Docket Item # BAR CASE # 2007-0085

City Council September 15, 2007

Appeal of a decision of the Board of Architectural Review, Old and

210 King Street

Figure 4 - Existing south elevation showing proposed demolition

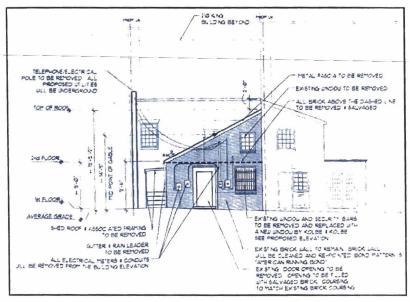
The Board denied the application for demolition of portions of the rear of the building because it believed that the amount of demolition presented was an unacceptable loss of historic fabric of an important building in the historic district. It was the conclusion of the Board that the demolition of portions of important historic buildings should be avoided.

In the opinion of Staff, this is an important late 18th/early 19th century structure that is significant for its architectural contributions to the patrimony of the historic district and the proposed demolition and capsulation and meets criterion #'s 1, 2, 3, 5 & 6. Staff believes that the proposed demolition represents a significant loss of the early architectural fabric of the historic district. The *Design Guidelines* state: "The Boards actively seek to retain the existing historic fabric of the historic districts and strongly discourage the demolition of any portion of an 18th or early 19th century structure." Therefore, staff recommends that the Permit to Demolish and Capsulate be denied.
